FOREST LAKES FILING NO. 6

CONSTRUCTION PLANS

EPC STORMWATER REVIEW COMMENTS
IN ORANGE BOXES WITH BLACK TEXT

FOREST LAKES FILING NO. 6 CONSTRUCTION PLANS TITLE SHEET			
DESIGNED BY	MAL	SCALE	DATE 08/04/2020
DRAWN BY	MES	(H) 1" = N/A	SHEET 1 OF 25
CHECKED BY		(V) 1" = N/A	JOB NO. 1175.60

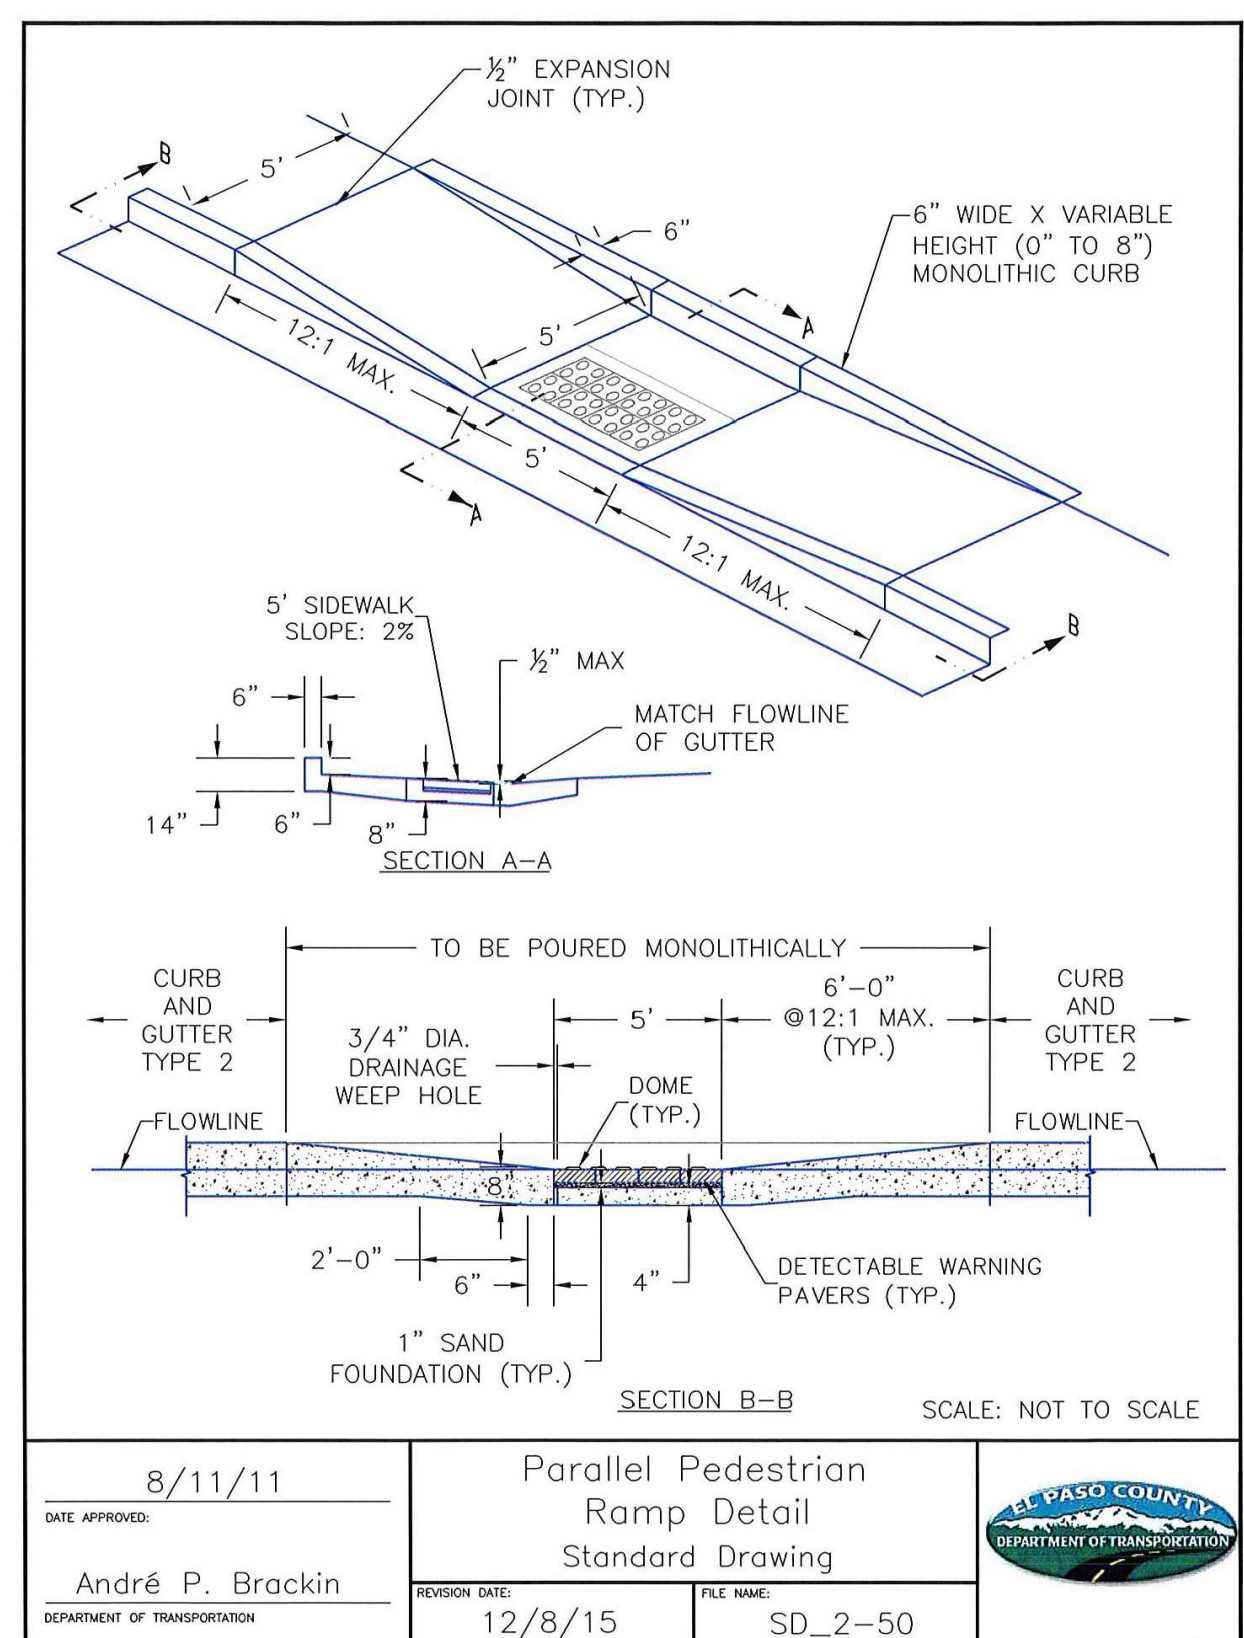
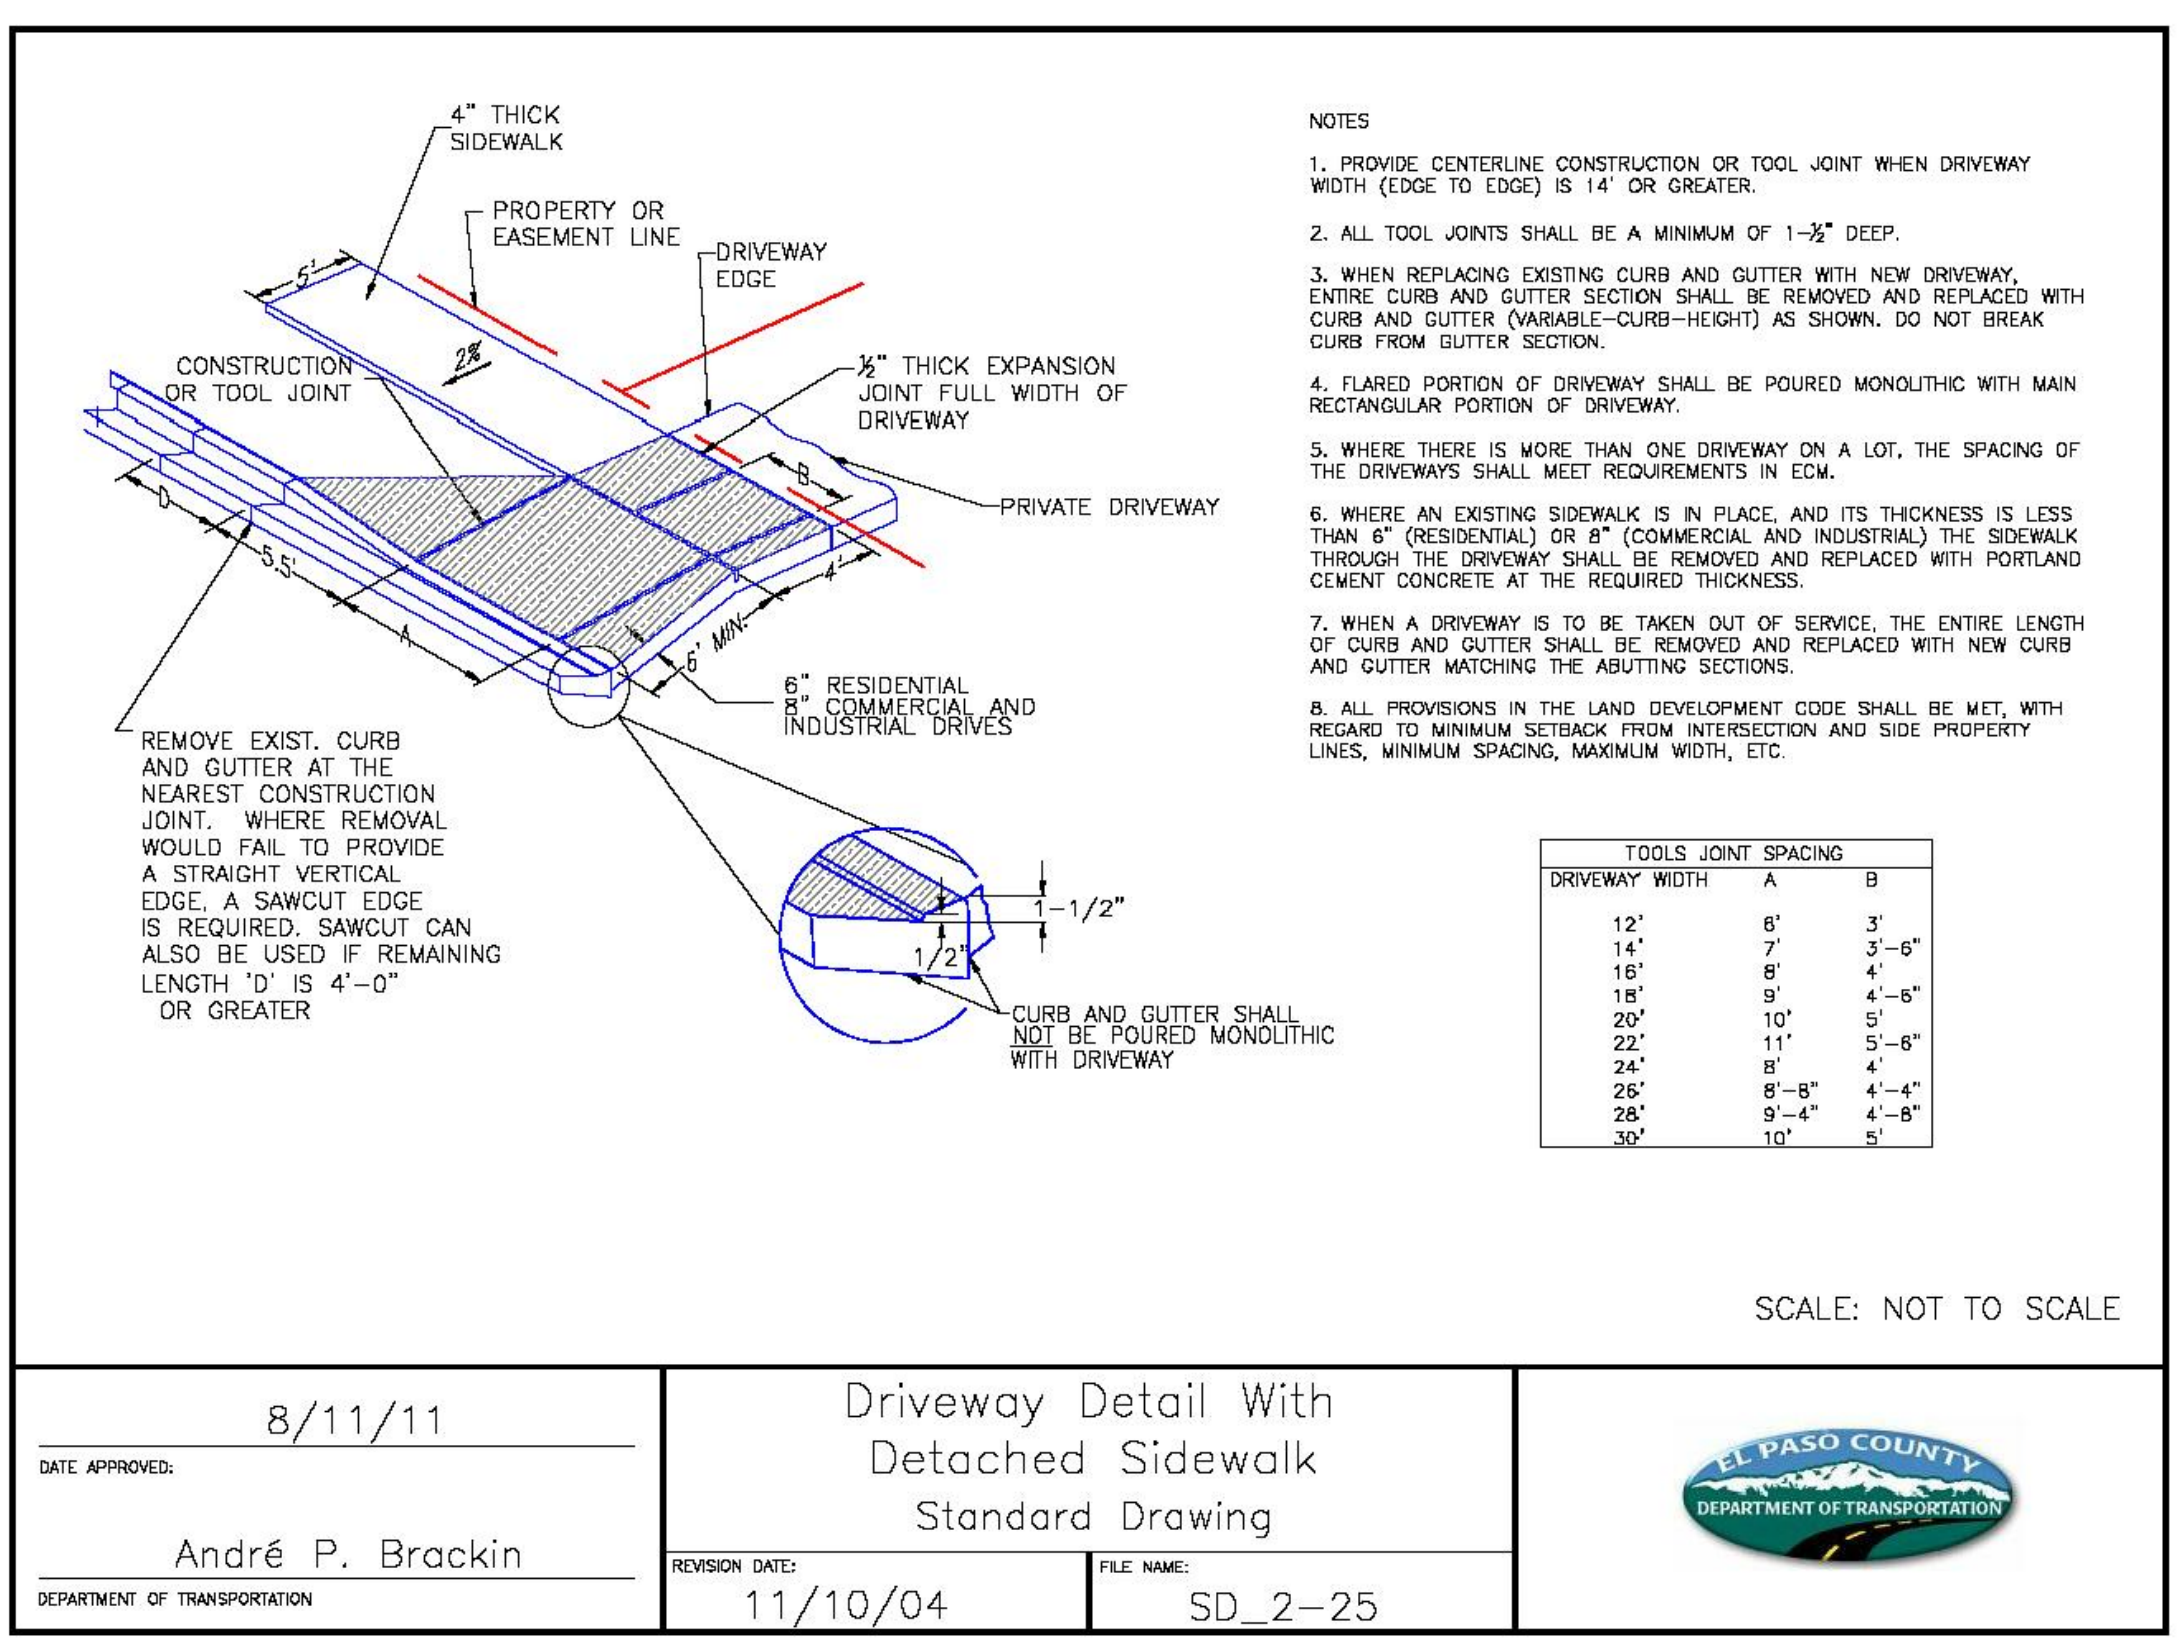
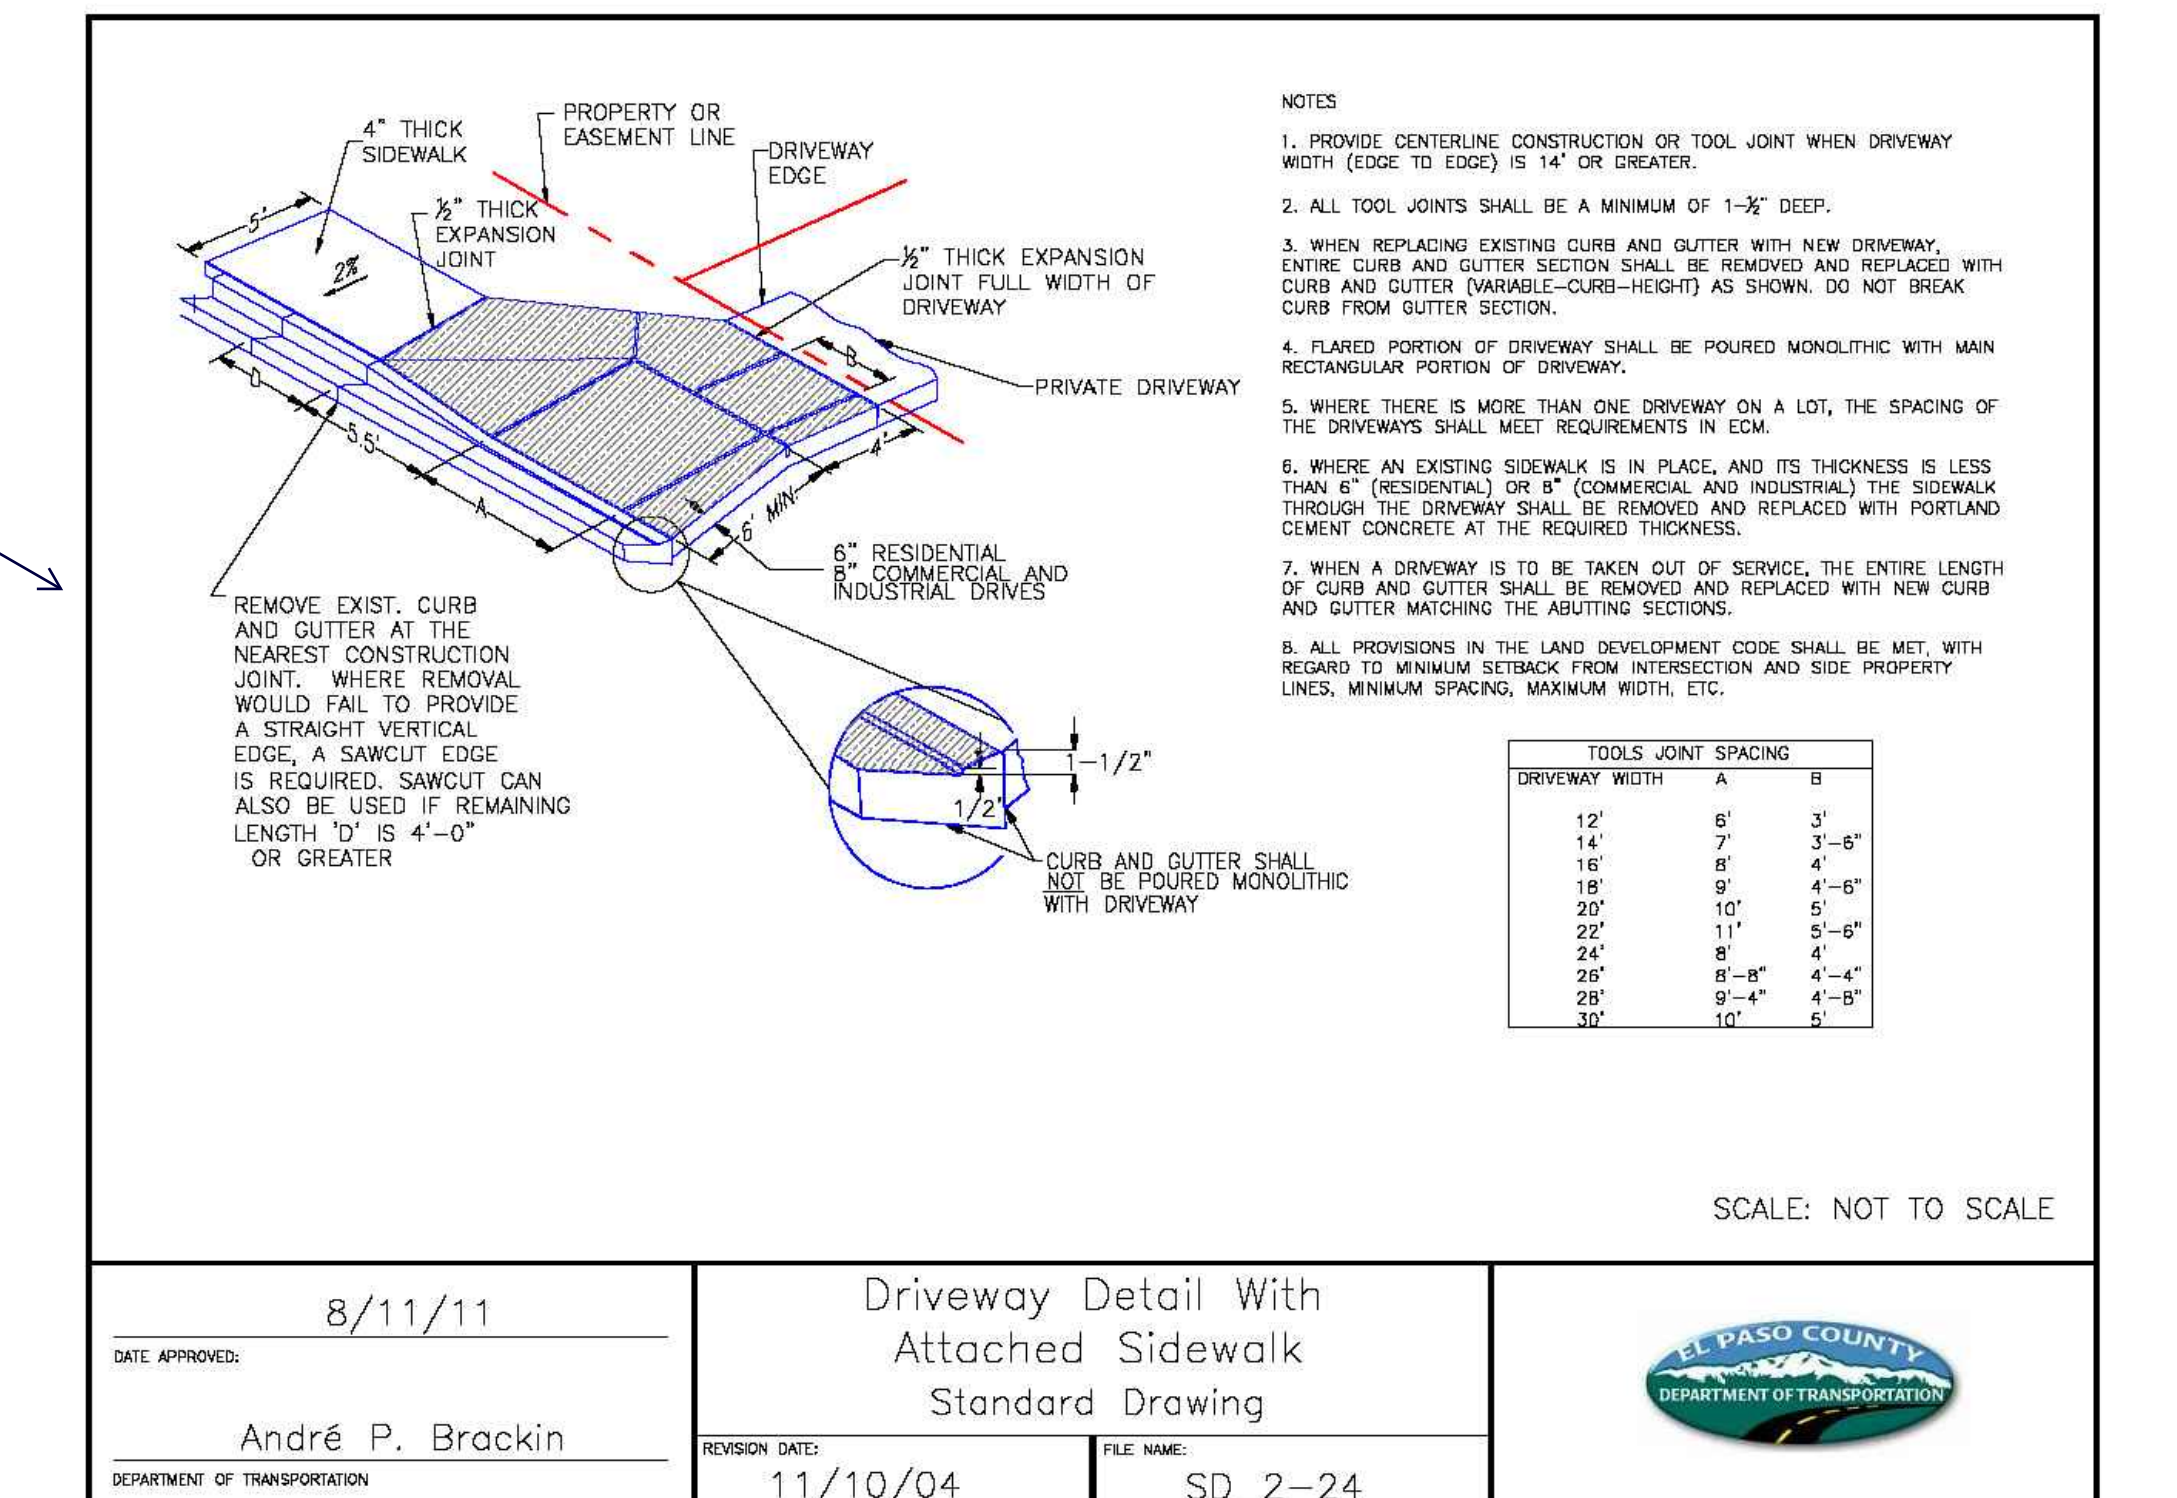
Replace details with the latest version which has a revision date of 6/23/20

Add details SD_2-41 & SD_2-42
